ALTERNATE LANDSCAPE PLAN
 FOR LOTS 1-5
 SKY-RIDGE ADDITION
 CITY OF ROCKWALL
 ROCKWALL COUNTY, TEXAS

SUBJECT: MIS2021-001; *Variance to the General Overlay District Landscape Buffer Requirement*

PROJECT NUMBER: MIS2021-001
PROJECT NAME: Variance Request for Landscape Buffer
SITE ADDRESS/LOCATIONS:
CASE CAPTION:

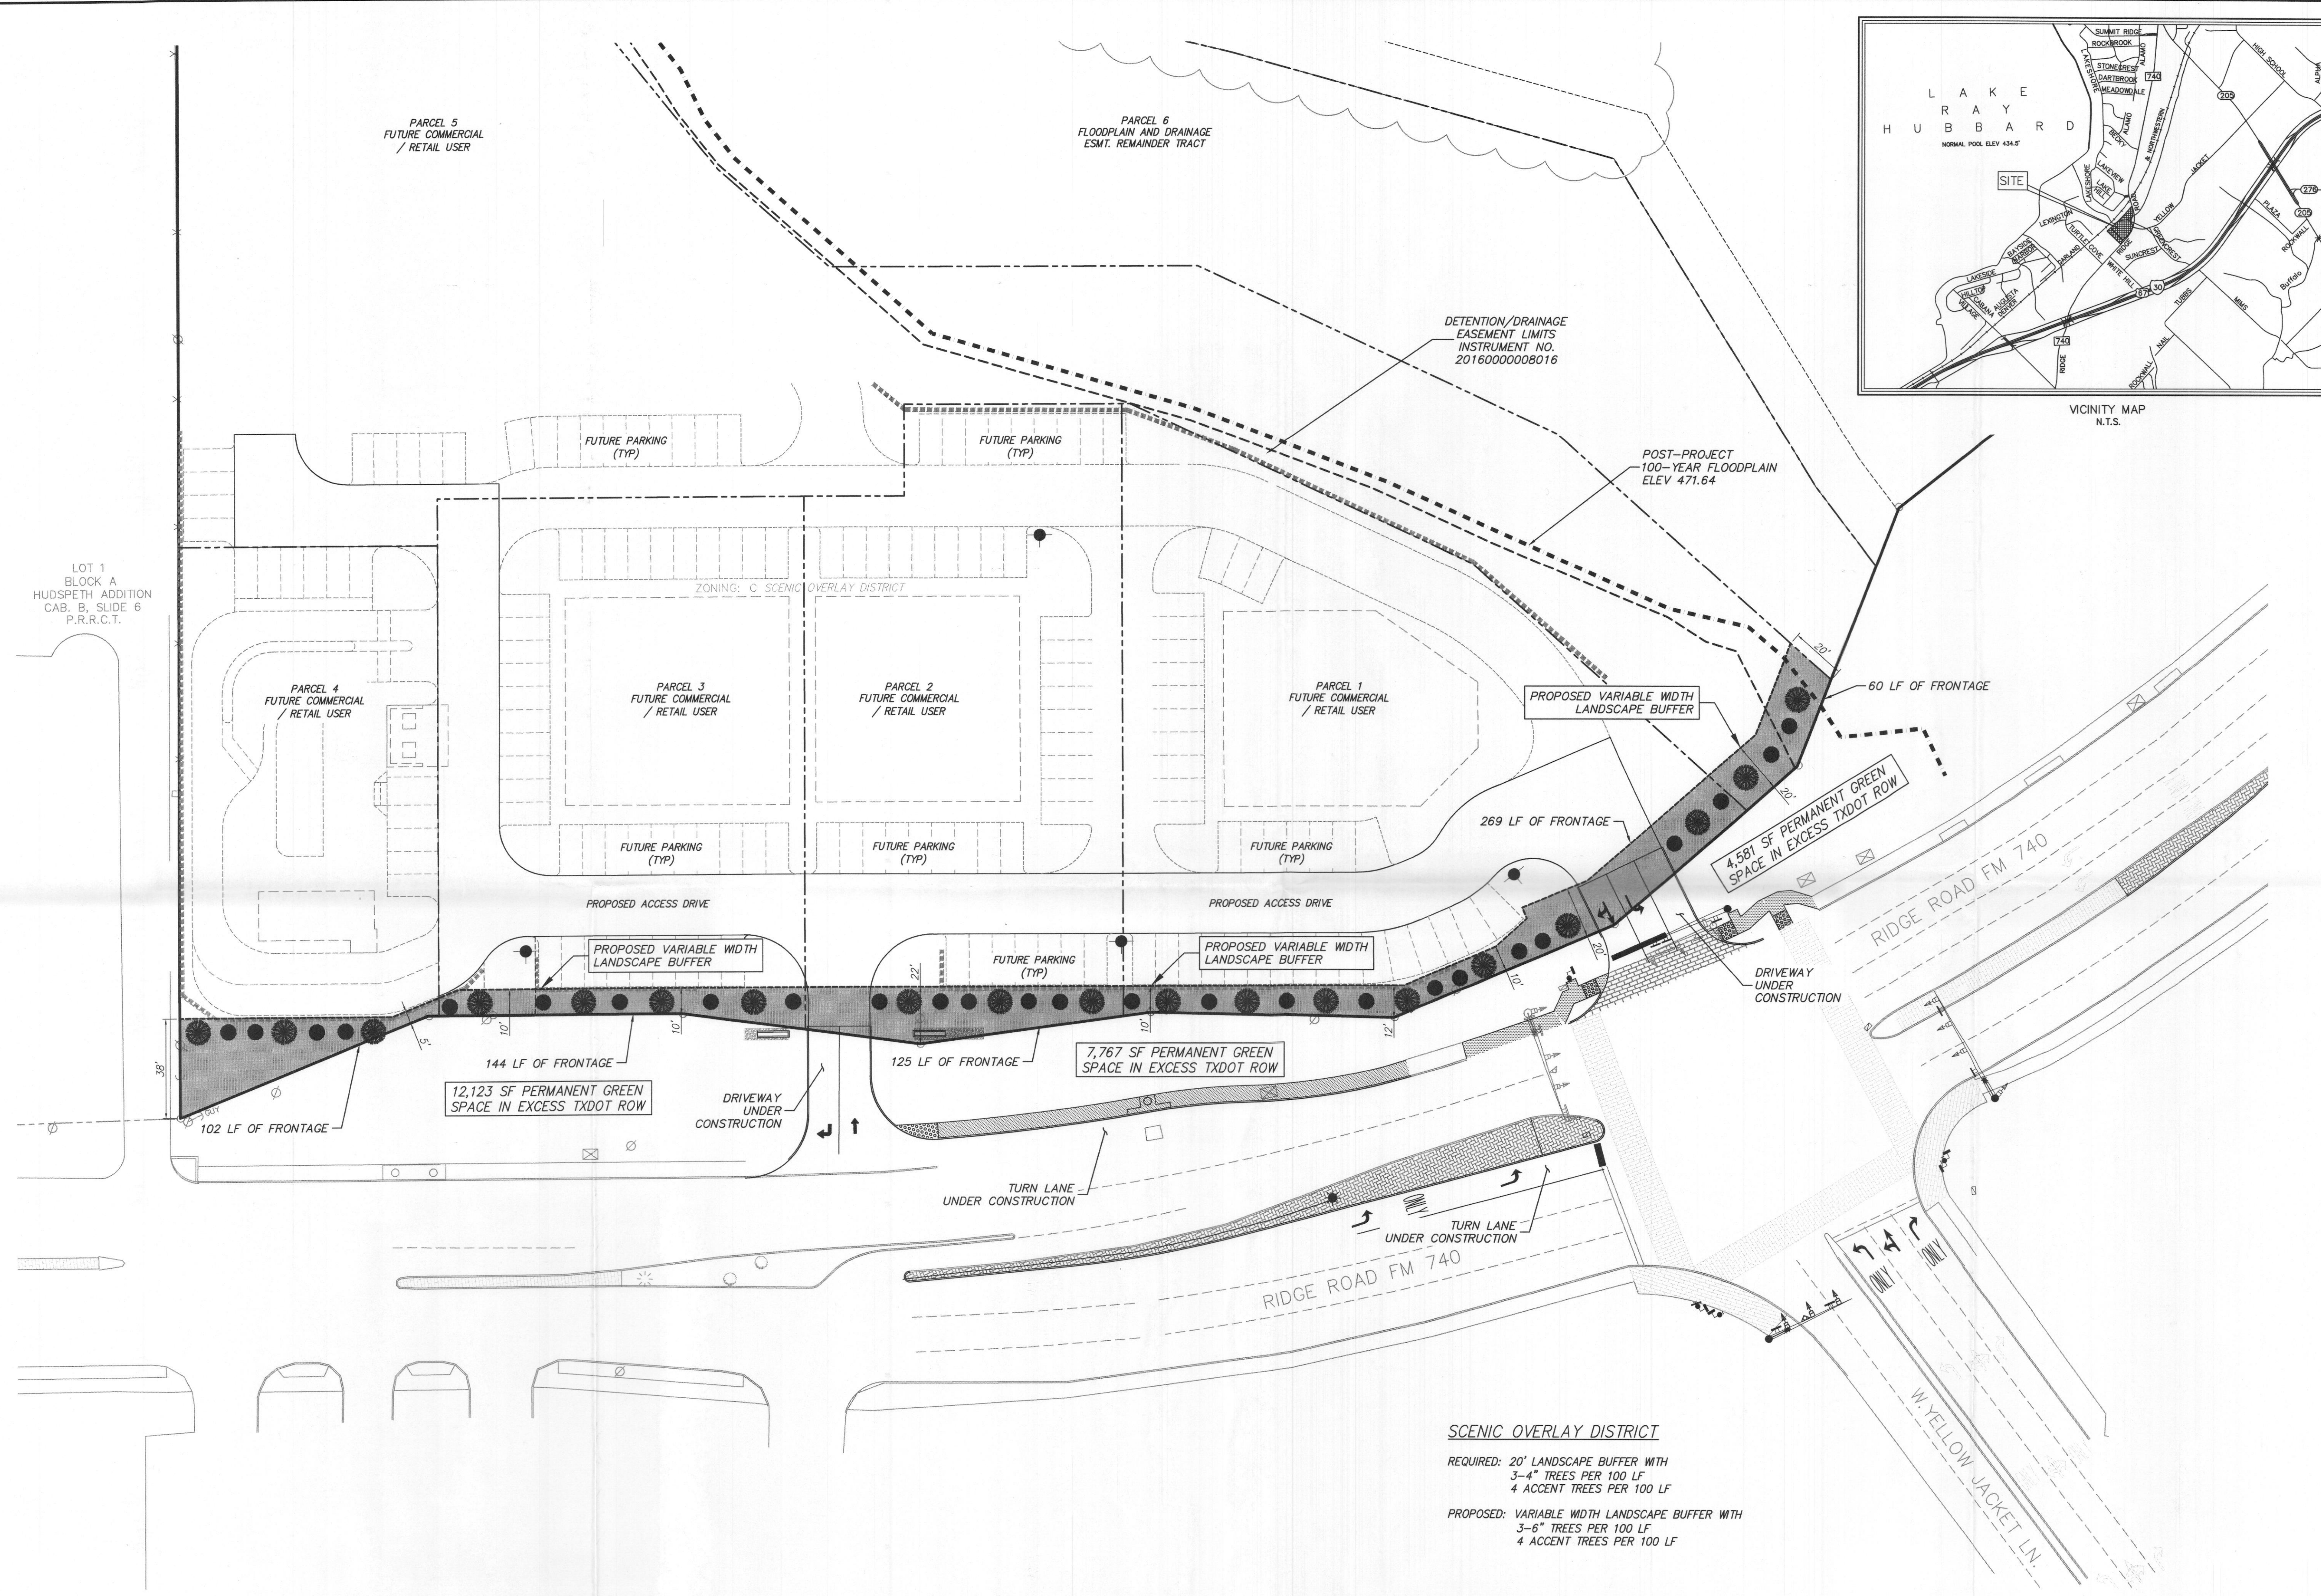
01/21/2021: M - Must show all existing water and sewer lines.
M - Trees must be 5' away from existing 8" water line.

- No trees to be with 10' of any public water, sewer or storm line that is 10" in diameter or larger.
- No trees to be with 5' of any public water, sewer, or storm line that is less than 10".

ALTERNATE LANDSCAPE PLAN

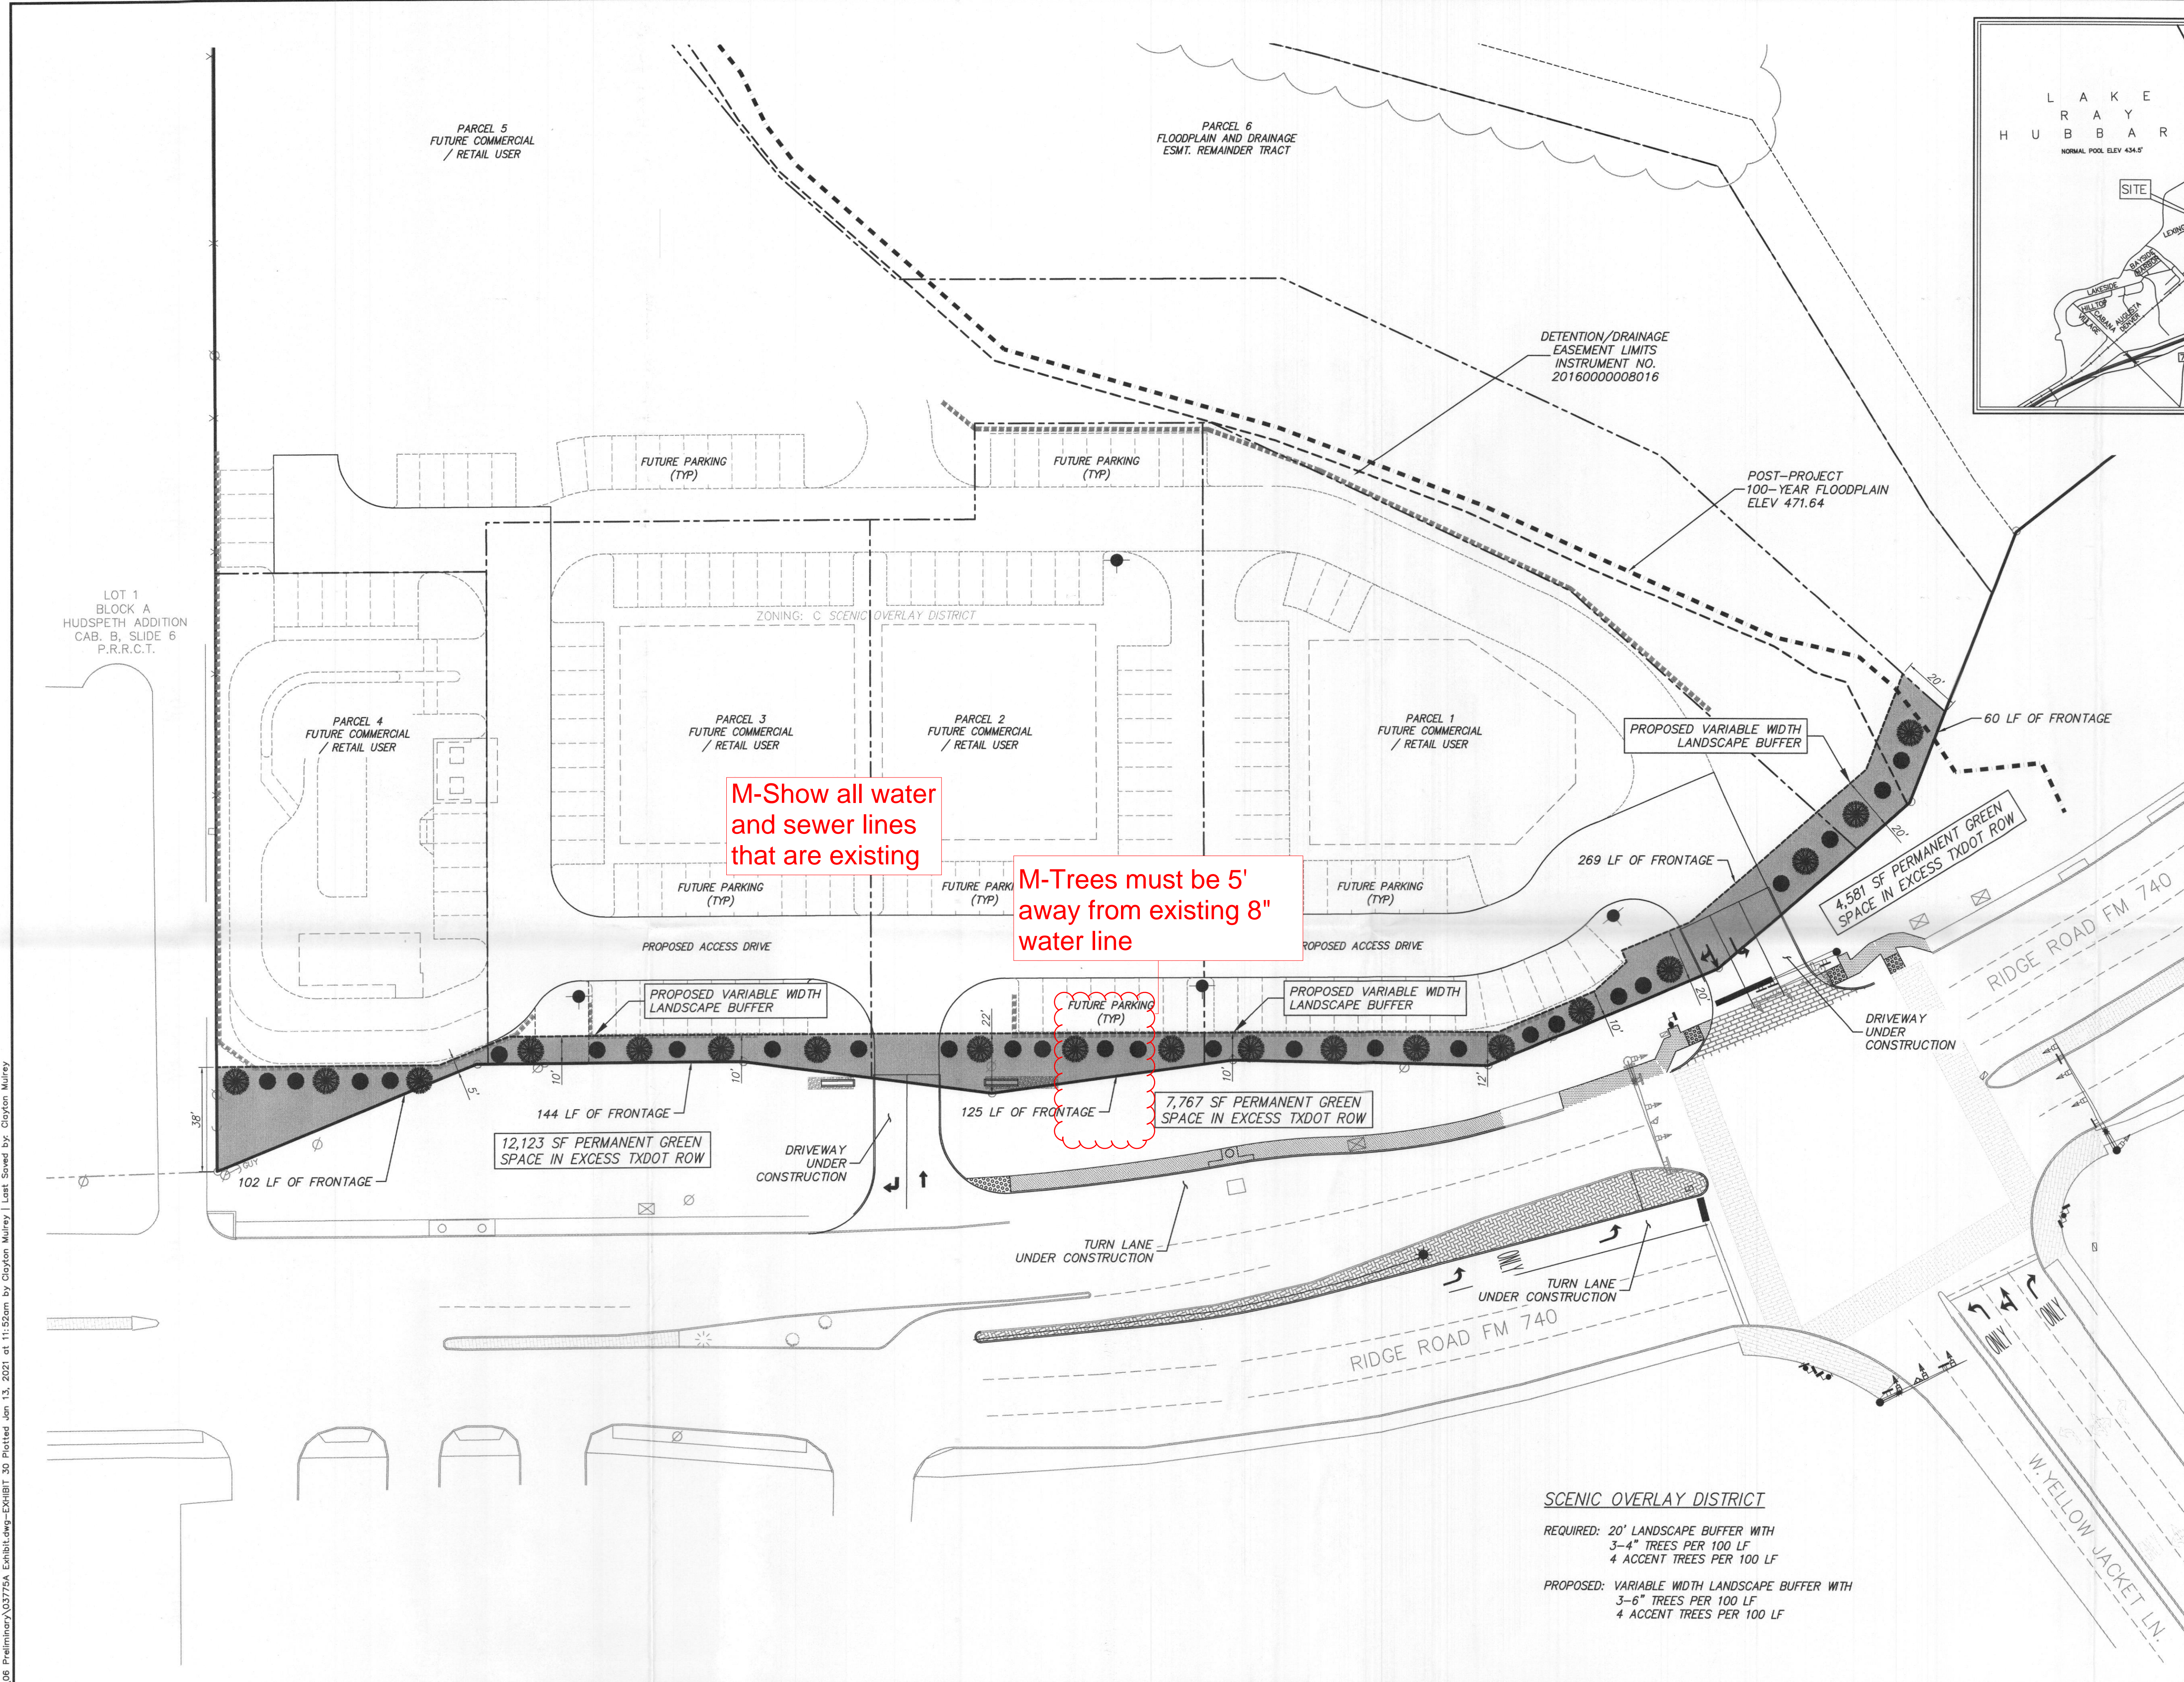
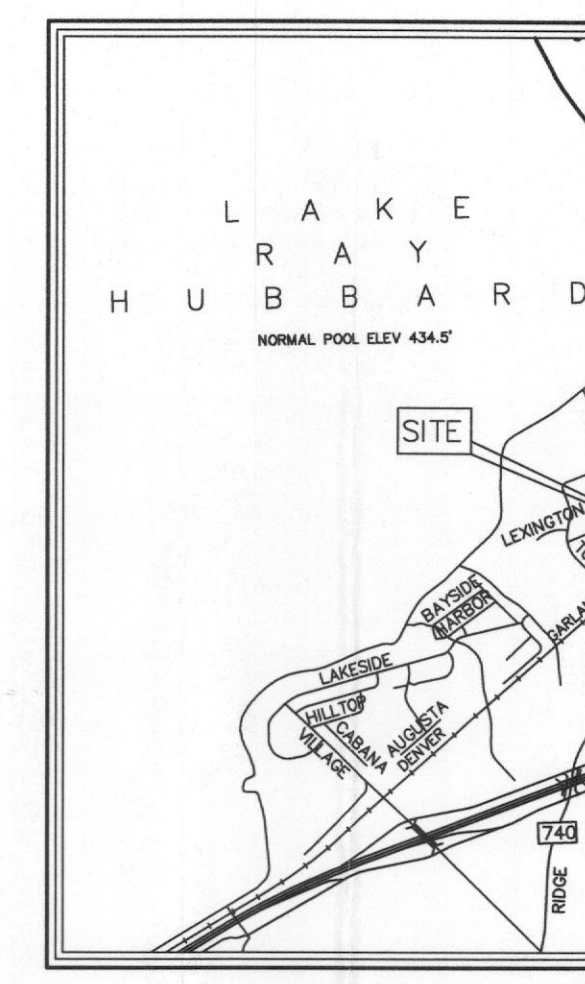
I.4 Please make the following changes to the Conceptual Landscape Plan:

a) Under the Scenic Overlay District heading, indicate the number of required canopy trees [i.e. 38, four (4)-inch trees] and number of required accent trees [50, four (4)-foot tall trees]. Additionally, indicate the number of proposed canopy trees [e.g. 38, six (6)-inch trees] and the number of required accent trees [50, six (6)-foot tall trees]

M.5 Provide a letter requesting the variance to the SOV minimum 20-foot landscape buffer, and the two (2) compensatory measures being proposed that would off-set the variance

M-Show all water and sewer lines that are existing

M-Trees must be 5' away from existing 8" water line
